Access Compliance Report Public Rights-of-Way (Curb Ramps)

Main Street: N/A Cross Street: CROWN_VALLEY_PKWY Location: W

ADA ID: RPRK211101120142 Ramp Type: Type 1 - Perpendicular Diagonal Initial Pass/Fail: Fail Overall Compliance: No Severity Score: 2

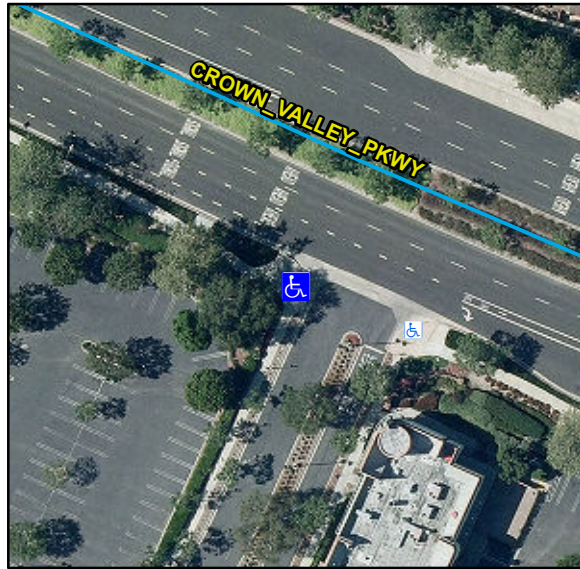
Compliance	Description	Data	Compliance	Description	Data
N/A	Ramp Length (in)	117	N/A	Flare Type LT	
Yes	Ramp Width (in)	48			N/A
Yes	Ramp Run Slope (%)	5.5	N/A	Flare Slope LT (%)	N/A
No	Ramp Cross Slope (%)	3.4	N/A	Flare Traversable LT	N/A
N/A	Landing Present	N/A	N/A	Flare Type RT	
N/A	Landing Length (in)	N/A			N/A
N/A	Landing Width (in)	N/A	N/A	Flare Slope RT (%)	N/A
N/A	Landing Run Slope (%)	N/A	N/A	Flare Traversable RT	N/A
N/A	Landing Cross Slope (%)	N/A	N/A	DWS Provided	N/A
N/A	Landing Movement Obstructed?	N/A	N/A	DWS Contrast	N/A
	Landing Movement Type	N/A	N/A	DWS Length (in)	N/A
N/A	Landing Shared	N/A	N/A	DWS Full Width	N/A
N/A	Clear Space	Yes	N/A	DWS Offset Left (in)	N/A
N/A	Clear Space To Crosswalk (in)	N/A	N/A	DWS Offset Right (in)	N/A
N/A	Marked Crosswalk 1	No	N/A	Marked Crosswalk 2	No
	Crossing 1 Direction	SE		Crossing 2 Direction	N
	Marked Crosswalk 1 Width (in)	N/A		Marked Crosswalk 2 Width (in)	N/A

Remove & Replace Curb Ramp With Two New Directional Ramps or Equivalent.

R204.3, R304.5.3, STD 1115
